Access Compliance Report

Public Rights-of-Way

(Curb Ramps)

Intersection ID: 20942	Main Street: CORONATION_BV	Cross Street: CROWN CENTRE_DR	Location: SE
ADA ID: D9EC1518DB15	Ramp Type: PerpDiag	Initial Pass/Fail: Fail	Overall Compliance: No
Severity Score: 12.5			
Codes/Mitigation Info/Possible Solution		Field Measurements/Component Compliance

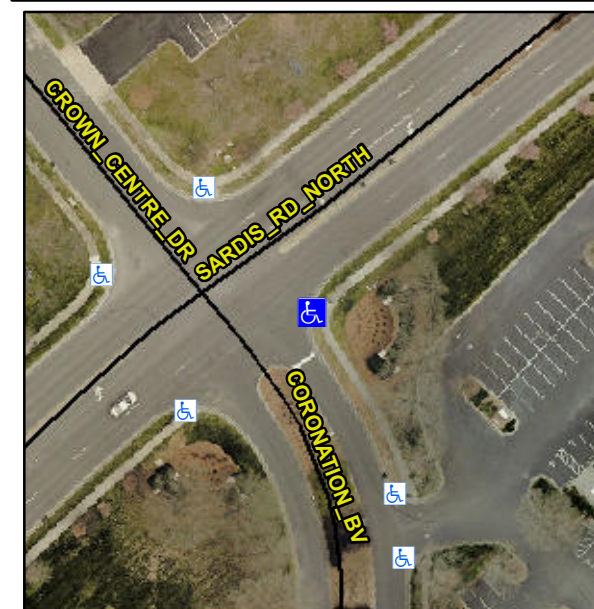
Compliance	Description	Data	Compliance	Description	Data
N/A	Ramp Length (in)	72.0	No	Ramp Slope (%)	11.7
Yes	Ramp Width (in)	48.0	Yes	Ramp XSlope (%)	1.5
N/A	Flare Type LT	N/A	N/A	Flare Type RT	N/A
N/A	Flare Slope LT (%)	N/A	N/A	Flare Slope RT (%)	N/A
N/A	Flare Traversable LT?	N/A	N/A	Flare Traversable RT?	N/A
N/A	Landing Length (in)	N/A	N/A	DWS Provided?	N/A
N/A	Landing Width (in)	N/A	N/A	DWS Contrast?	N/A
N/A	Landing Slope (%)	N/A	N/A	DWS Length (in)	N/A
N/A	Landing X Slope (%)	N/A	N/A	DWS Full Width?	N/A
N/A	Landing Curb? (Y/N)	N/A	N/A	DWS Offset (in)	N/A
N/A	Shared Landing?	N/A			
N/A	Gutter Ponding?	N/A	N/A	Gutter Slope (%)	N/A
N/A	Gutter Lip Ht (in)	N/A	N/A	Gutter X Slope (%)	N/A
N/A	Painted X Walk1?	No	N/A	Painted X Walk2?	No
	X Walk 1 Direction	To NW		X Walk 2 Direction	To SW
N/A	X Walk 1 Width (in)	N/A	N/A	X Walk 2 Width (in)	N/A
	X Walk 1 Slope (%)	3.0		X Walk 2 Slope (%)	5.1
	X Walk 1 X Slope (%)	6.8		X Walk 2 X Slope (%)	2.0

Remove & Replace Curb Ramp With Two New Directional Ramps or Equivalent.
